AMENDMENTS TO THE DRAWINGS

In response to the Office action identified above,
Fig. 2-5 has been revised. One clean copy of Fig. 2-5
5 has been provided along with one marked copy showing
the changes made.

Fig. 2

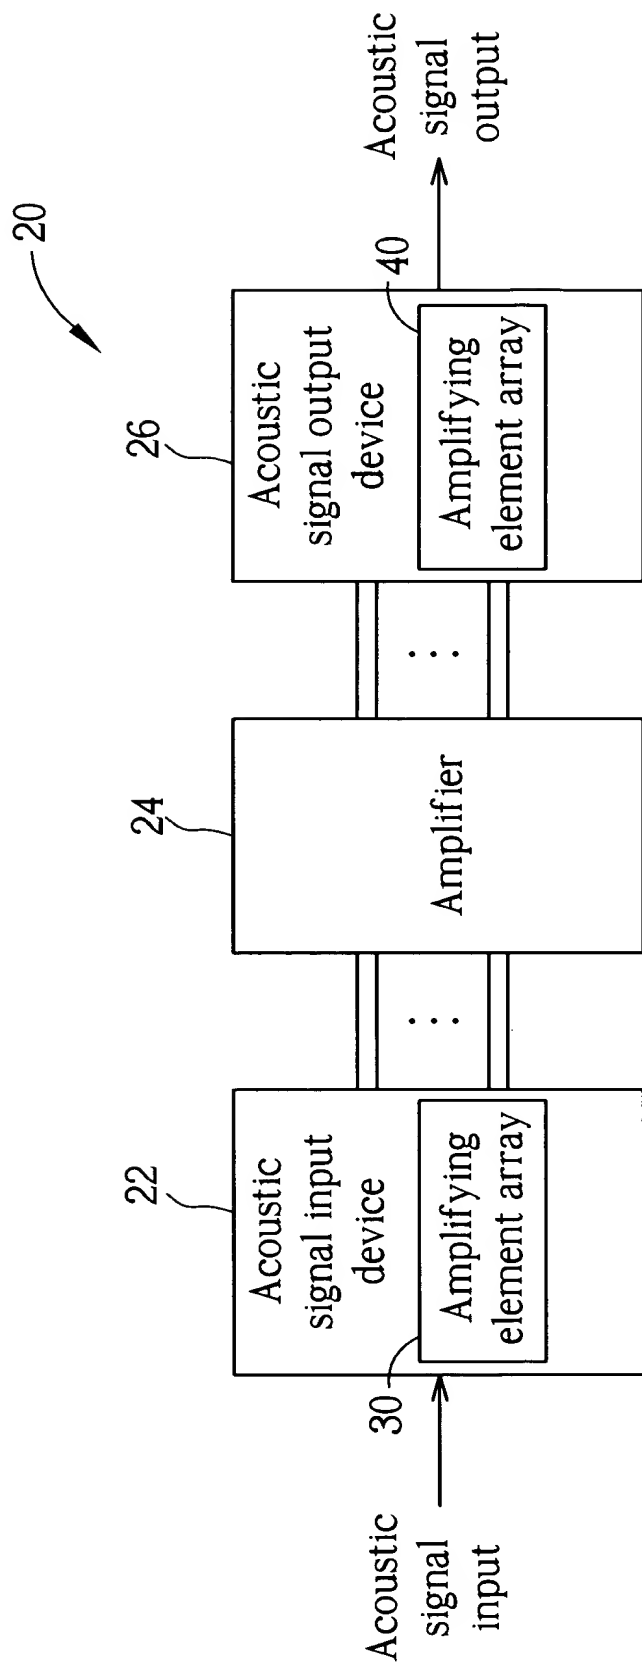
In Fig. 2, the acoustic signal input device (22)
comprises an amplifying element array (30), and the
acoustic signal output device (26) comprises another
10 amplifying element array (40). The hearing aid device
receives an acoustic signal input and outputs an acoustic
signal output.

Fig. 3

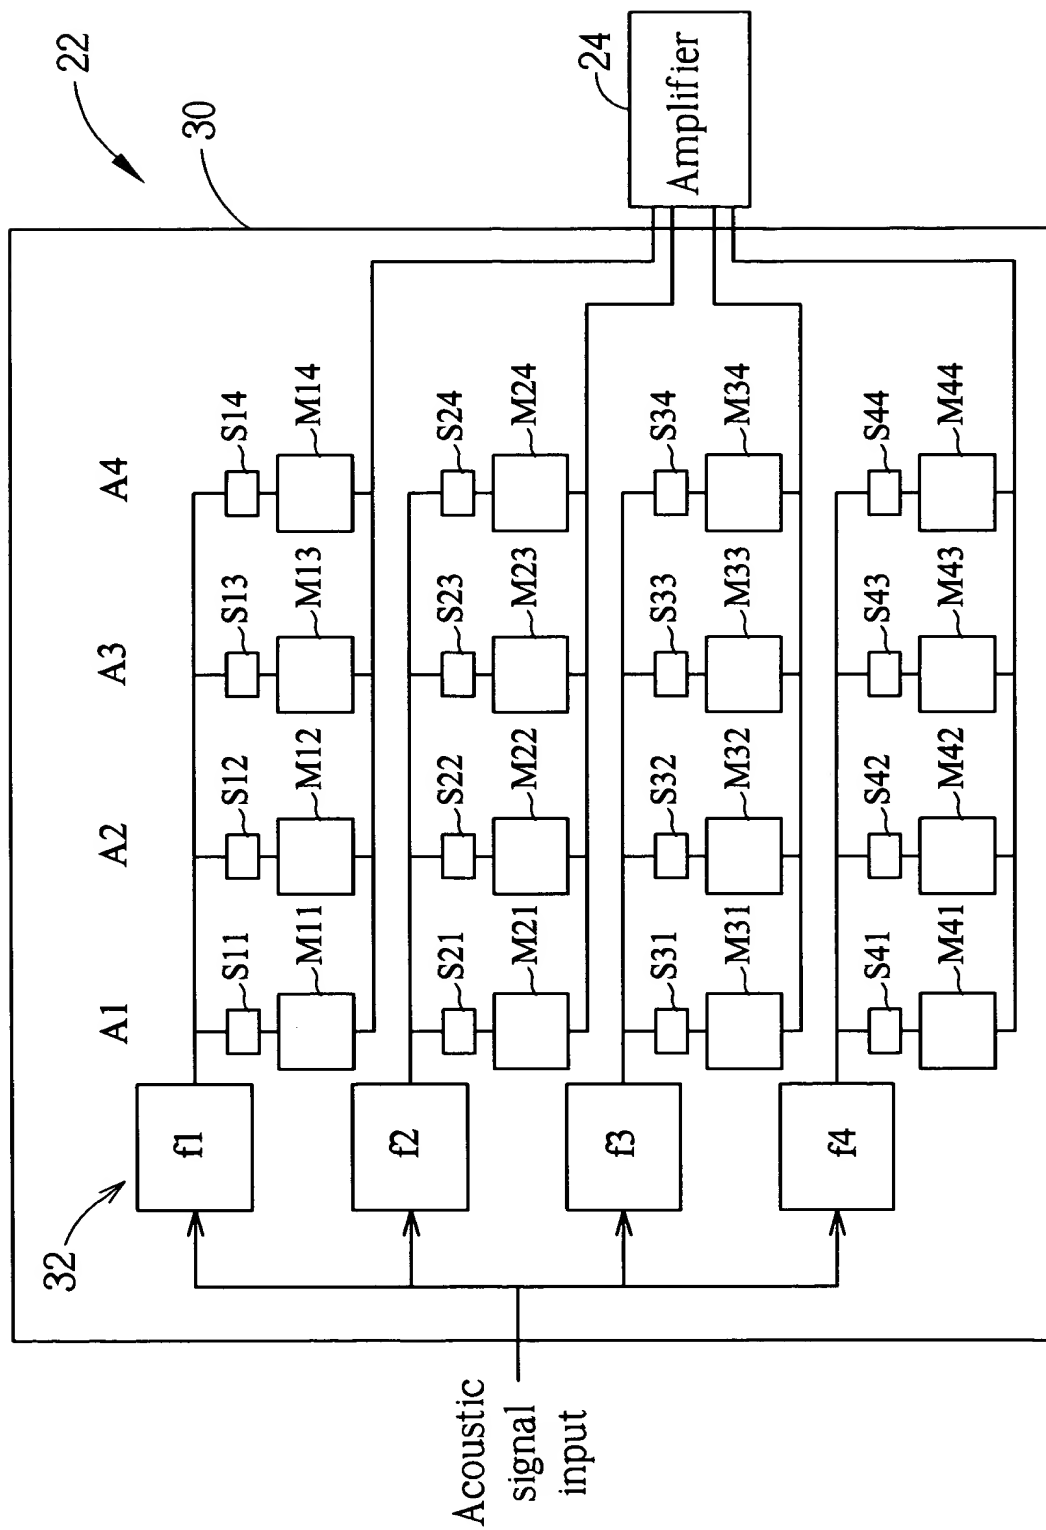
In Fig. 3, the acoustic signal input device (22) receives
an acoustic signal input and comprises an amplifying element
15 array (30).

Fig. 4

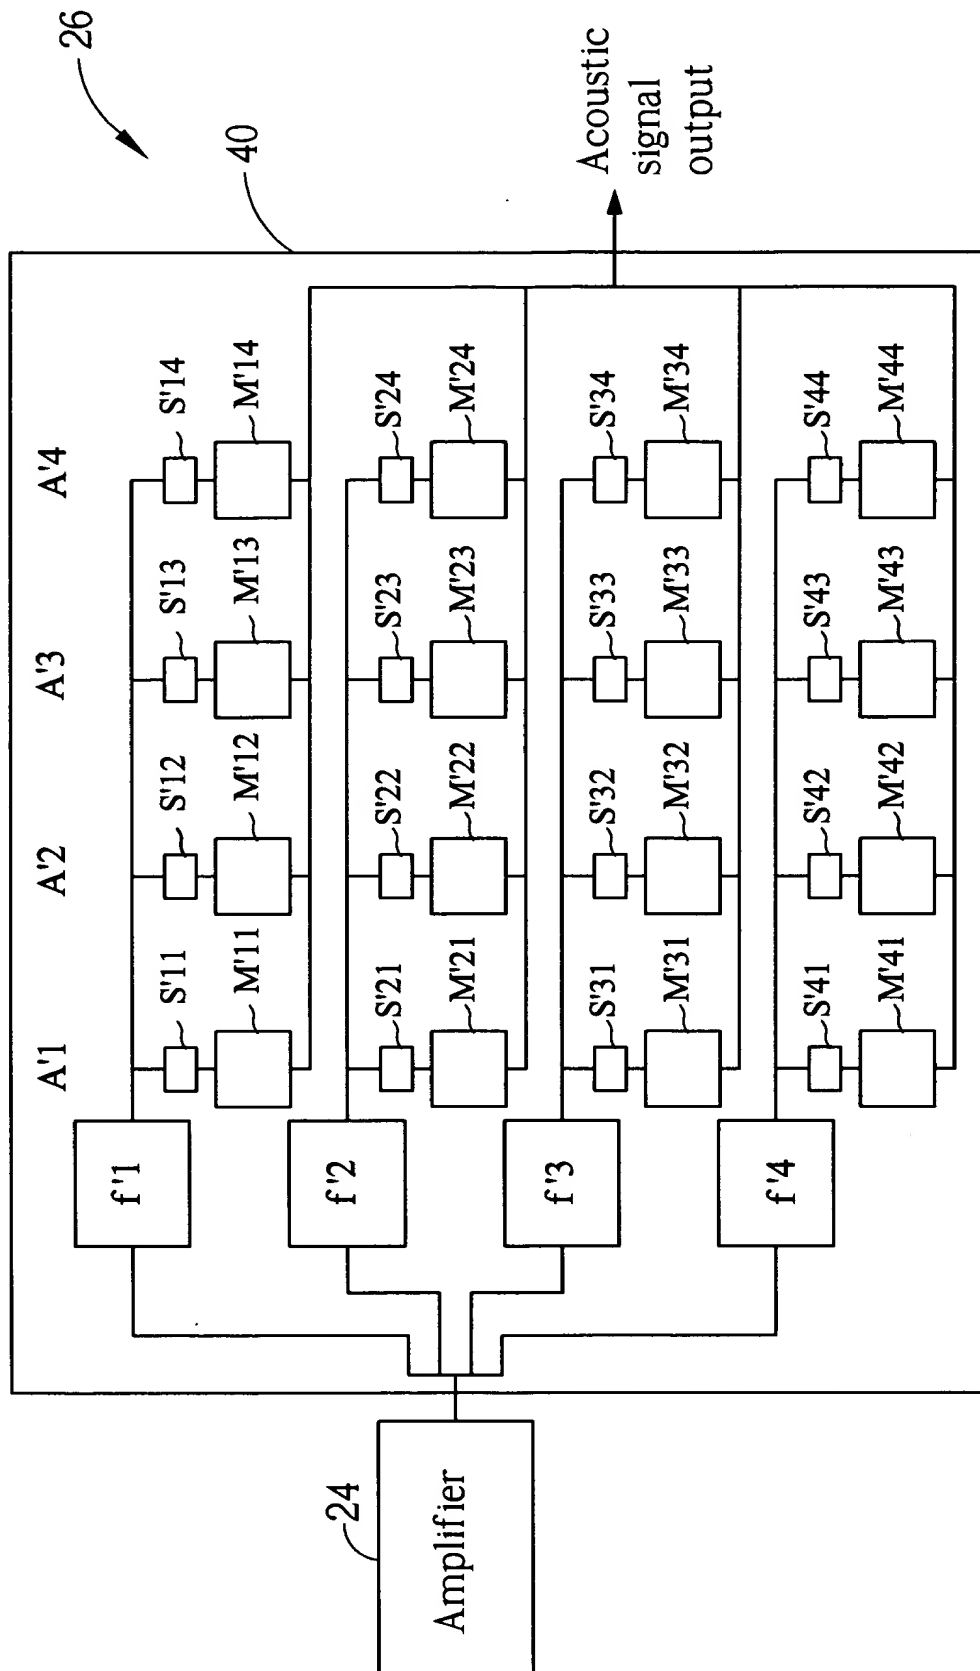
In Fig. 4, the acoustic signal output device (26) comprises
an amplifying element array (40) and outputs an acoustic signal
output.

Fig. 5

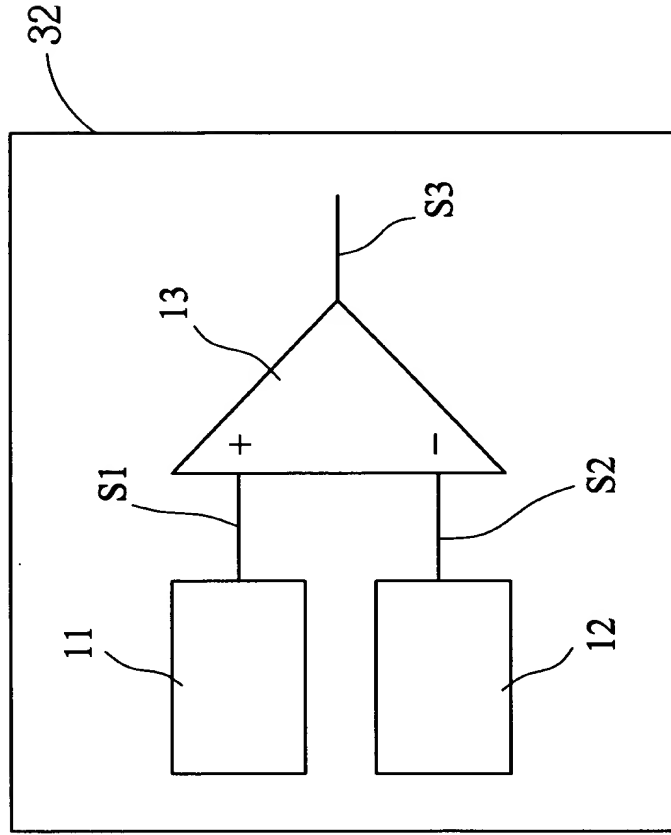
In Fig. 5, the bandpass filter (32) comprises two acoustic
20 receiving units (11), (12) with different resonant
frequencies and a differential amplifier (13).
